CITY OF ALBUQUERQUE

**Re: 9000 Alameda Blvd. Grading & Drainage Plan
Engineer's Stamp Dated Missing
(C20D073)**

GRADING & DRAINAGE PLAN

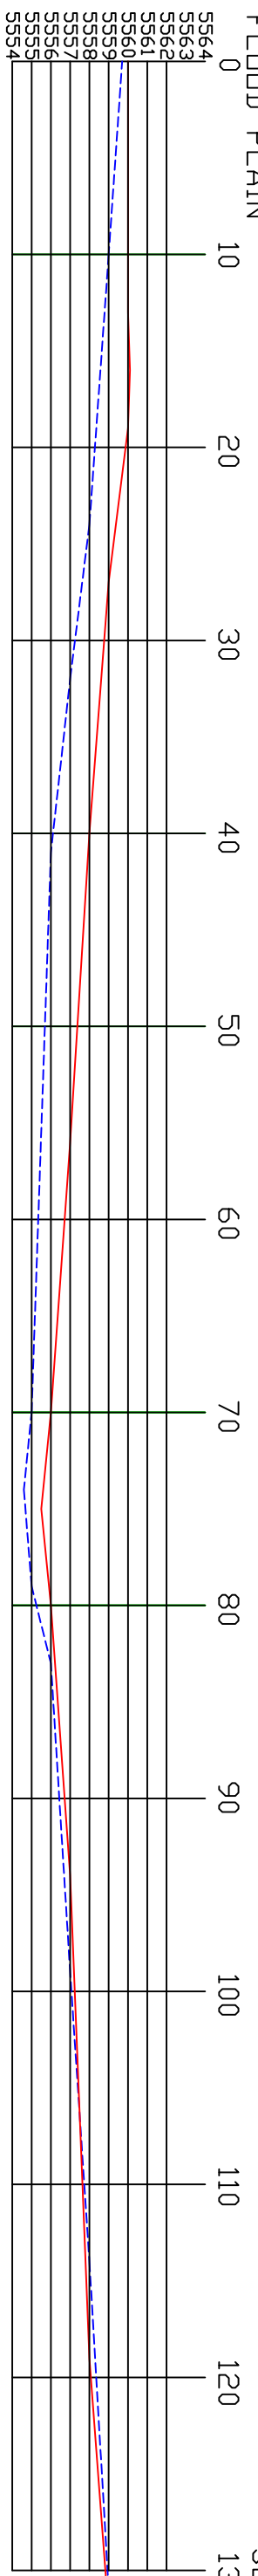
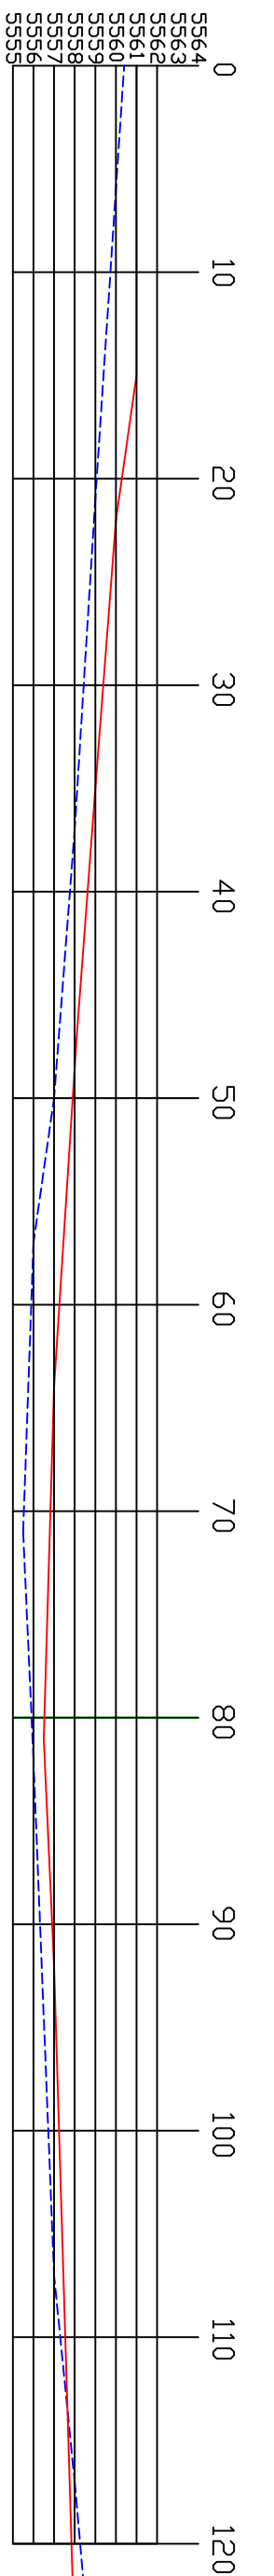
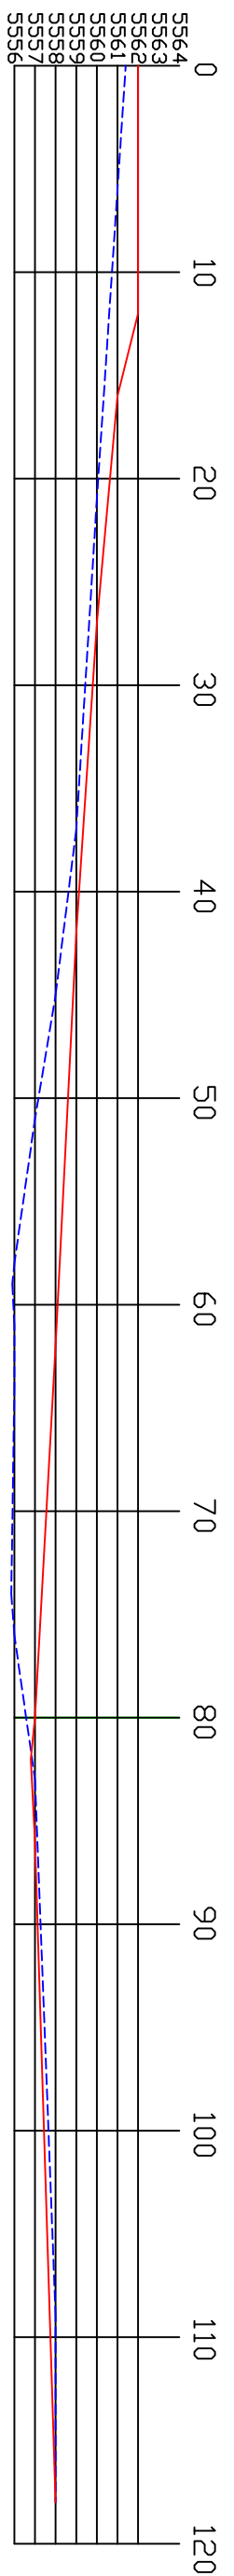
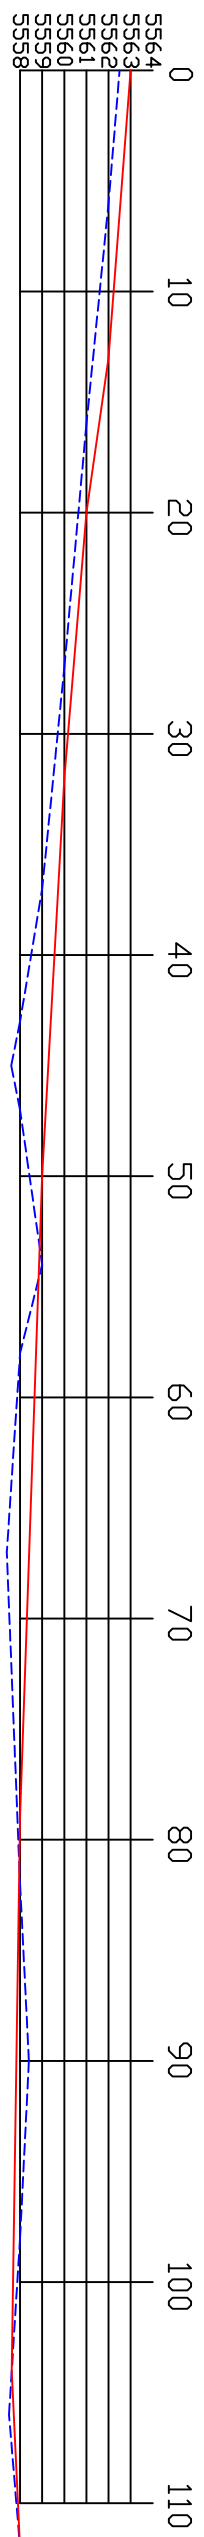
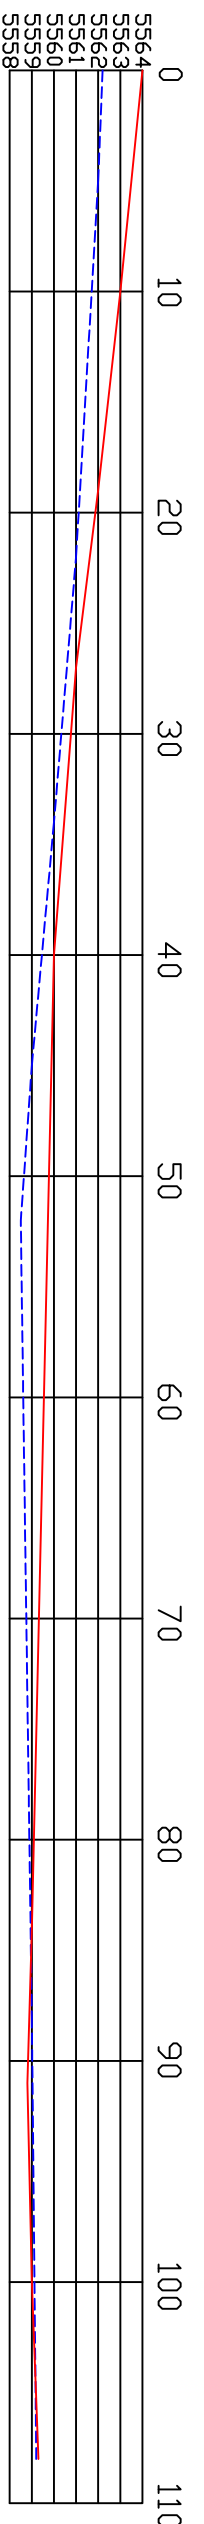
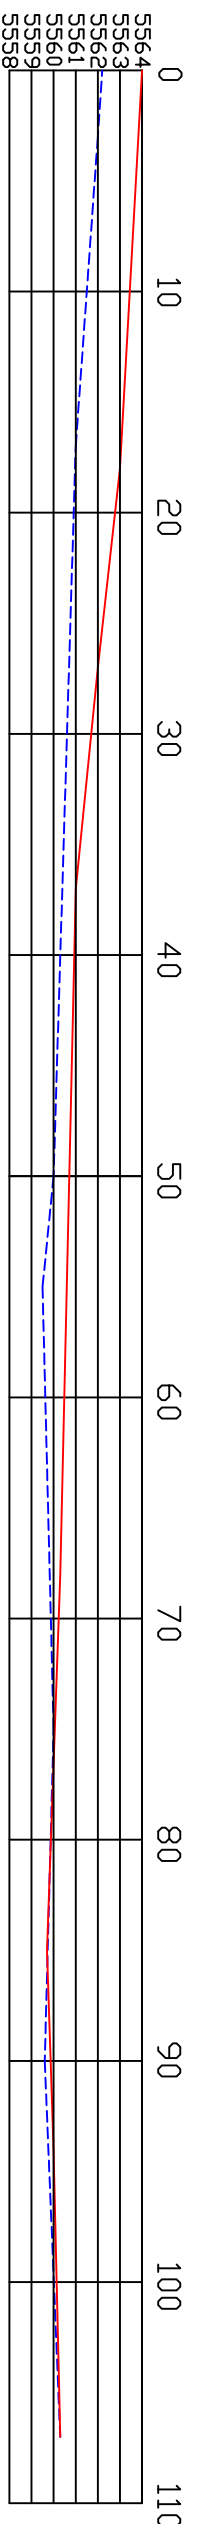
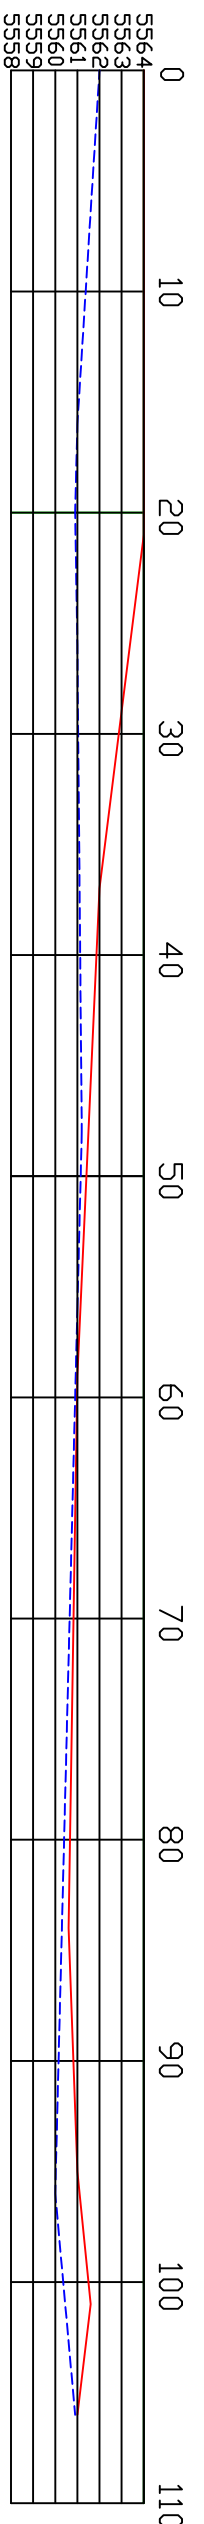
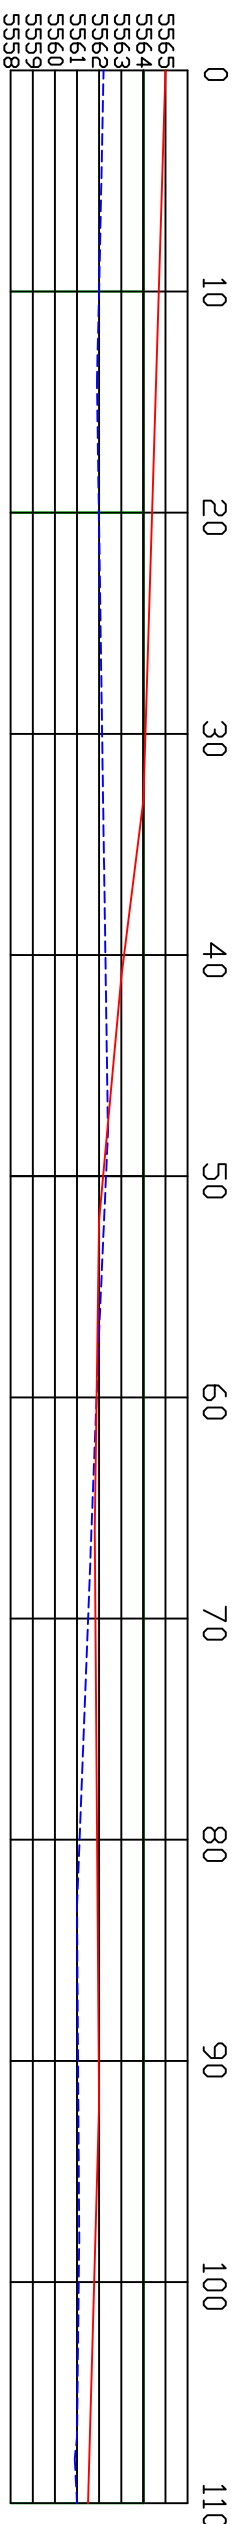
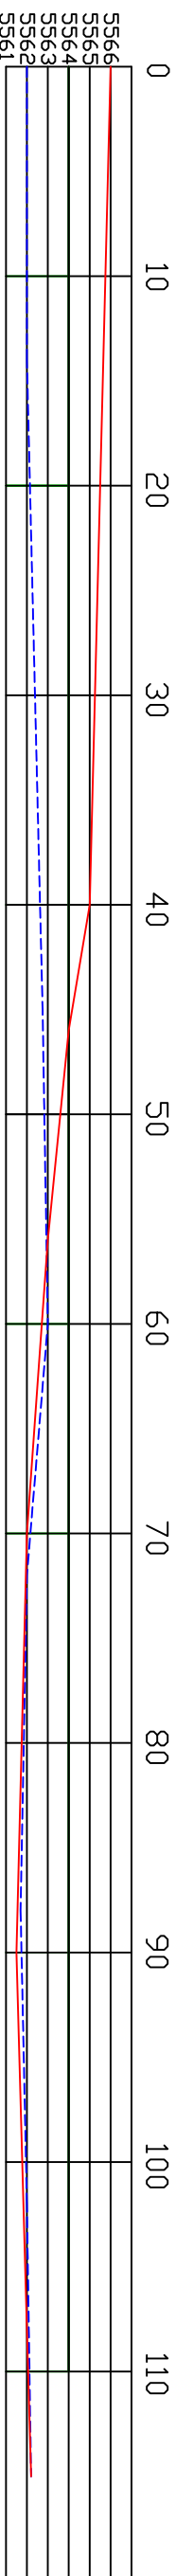
- Add a note prohibiting Construction in the arroyo during the months of July, August, and September.
- Show the proposed grades necessary to restore the floodplain drainage capacity with proposed contours and spot elevations. Verify that the proposed trapezoidal section will restore the original cross sectional area by plotting the finished grade on the sections.

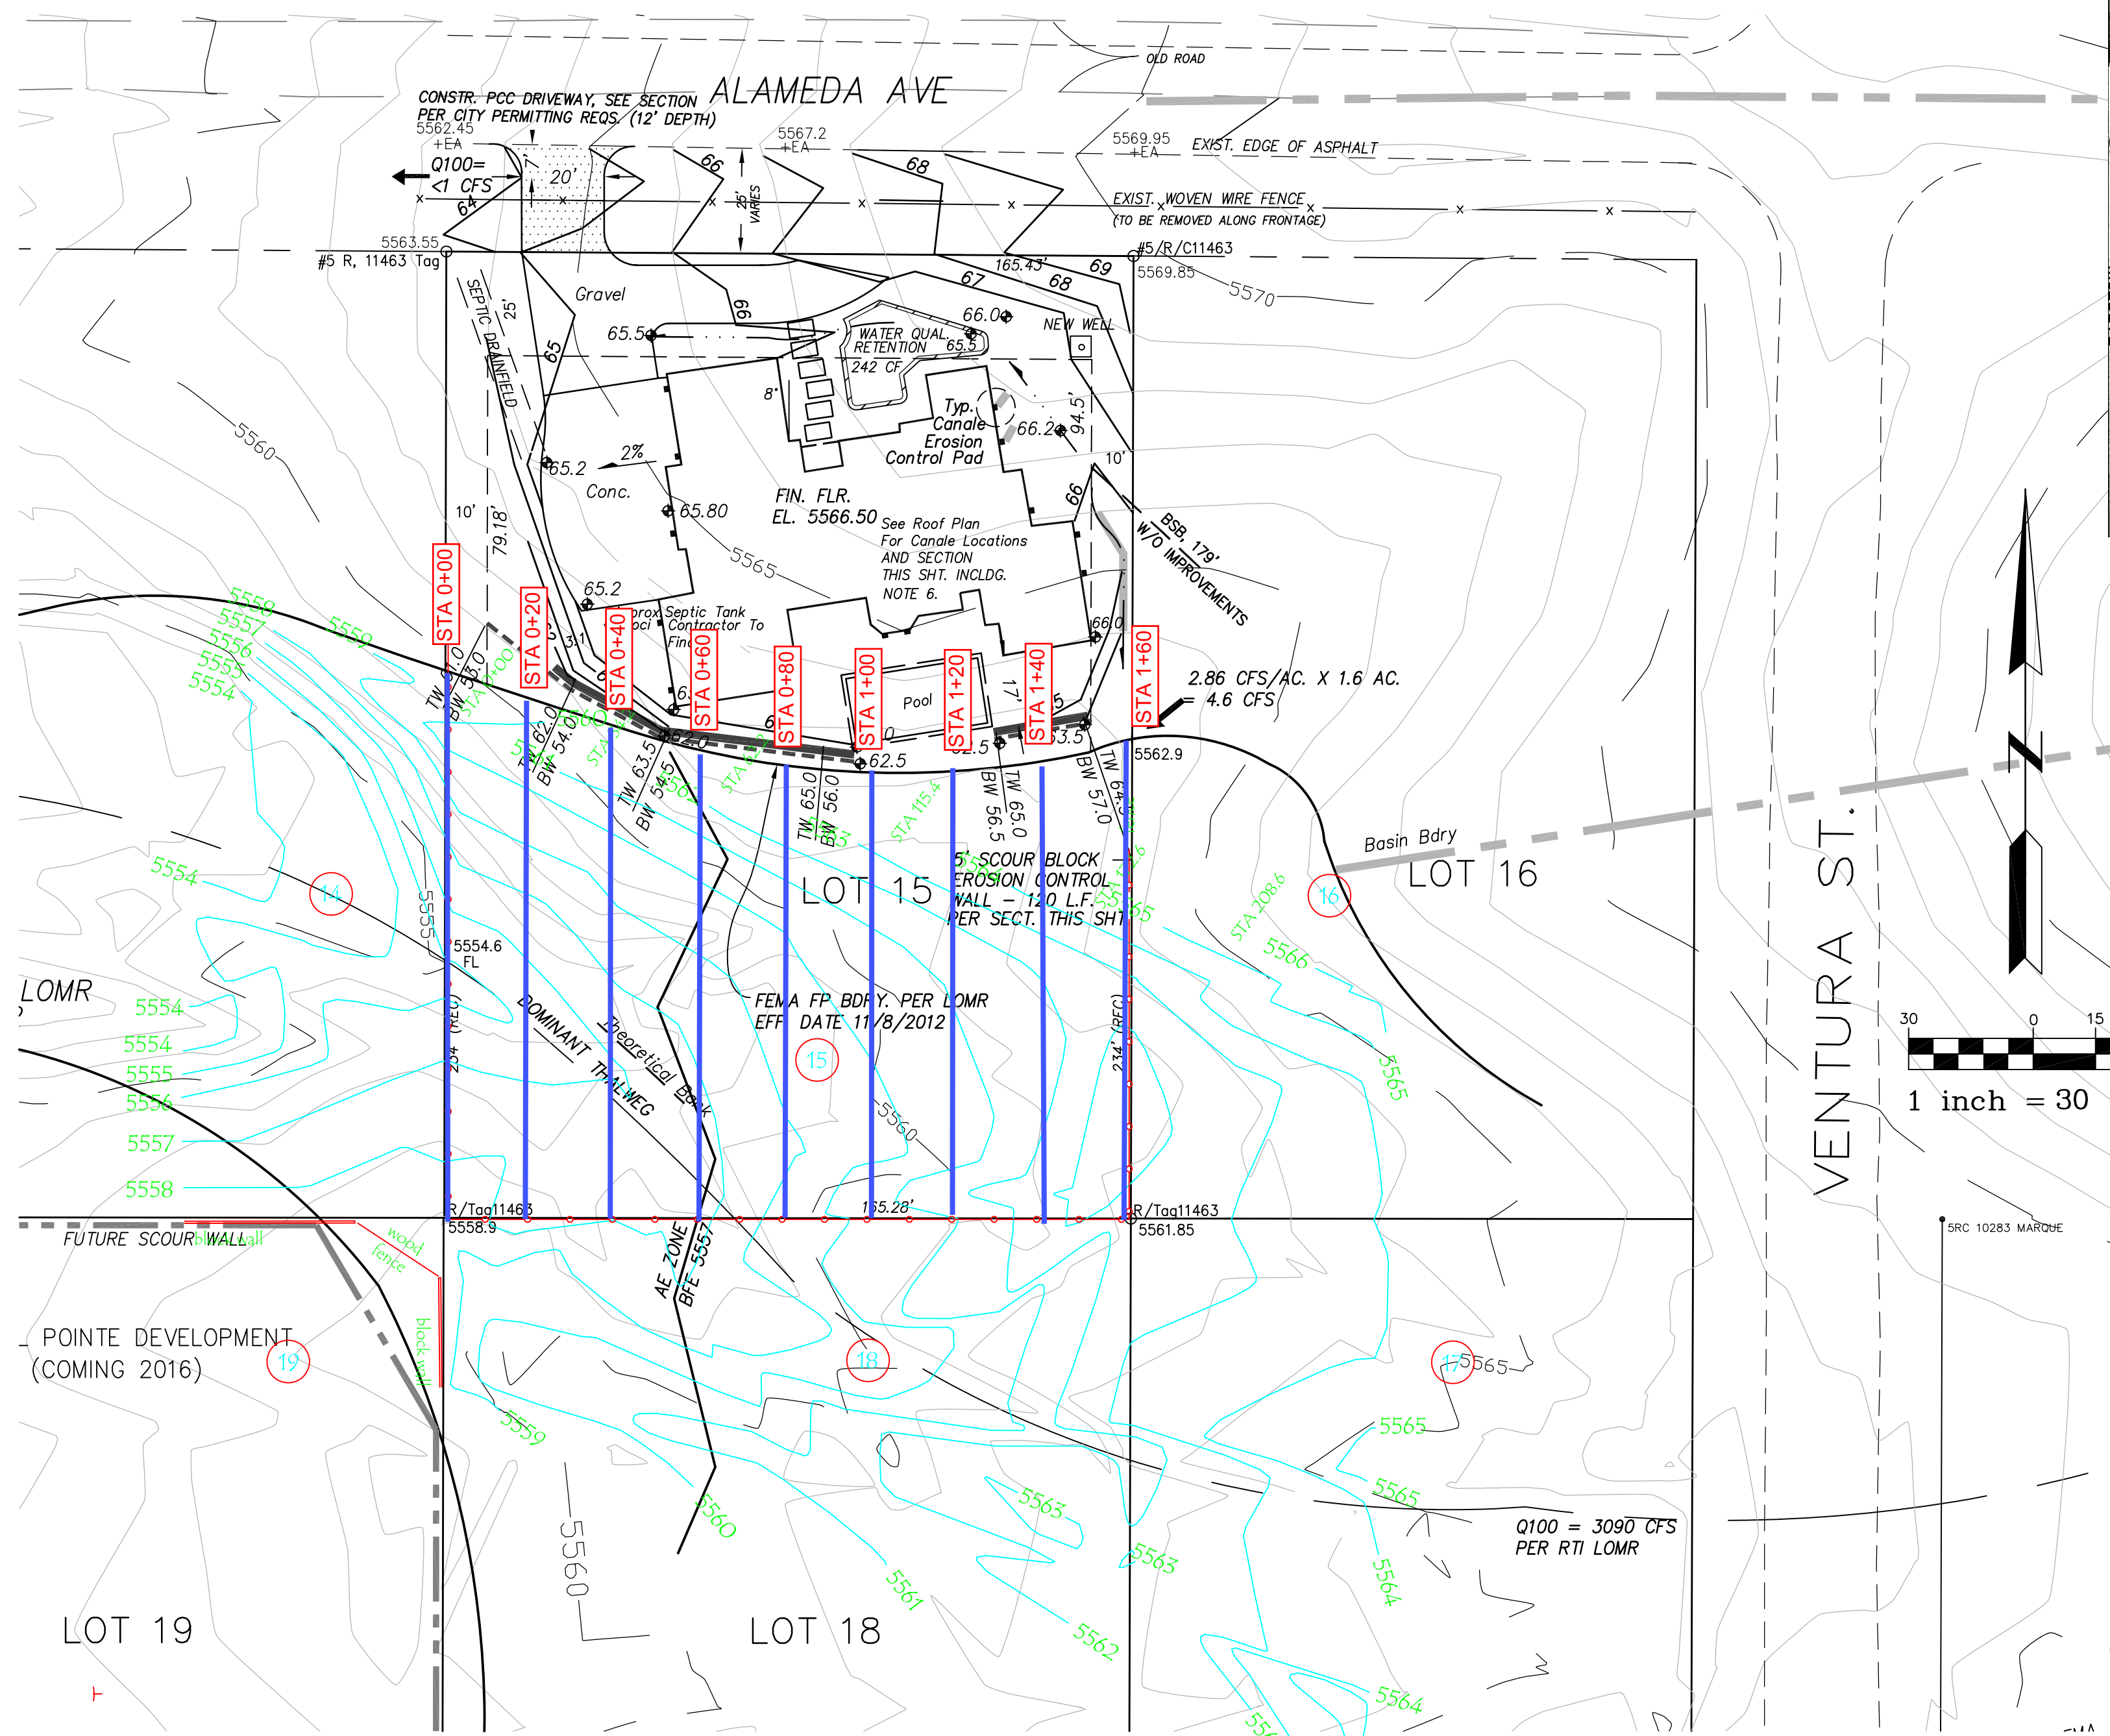
- Add a narrative statement to the plan describing the proposed activity as Restoration of Floodplain and Waters of the US. Include a description of the violation (fill, a fence, and a berm disrupt flood flows and the sediment transport is disrupted by replacing the natural sand bottom with foreign material).

- Written approval of the plan is required from the Corps of Engineers.
- Include notes identifying the limits of land disturbance and the area to be stabilized with native seed and mulch.

- Include a profile of the arroyo showing existing and proposed grades. Add a typical section, about 30' flat bottom trapezoidal channel.
- Extend the grading upstream of the property about 20' as necessary to restore the original grade there.

- Provide sufficient horizontal and vertical control for construction staking and as-builts.
- Show a Public Drainage Easement 55' wide at the east PL, 105' wide at the west PL, and 70' wide at a point 50 east of the west PL. Provide the signed and notarized original easement to Madeline Caruthers along with a check for 25\$ payable to Bernalillo County.
- Show the relocated fence outside of the Public Drainage Easement, and identify the existing fence to be removed from within the public drainage easement.
- An ESC plan must be submitted to Stormwater Quality Control. After the ESC plan is approved an ESC Permit must be obtained prior to beginning construction.
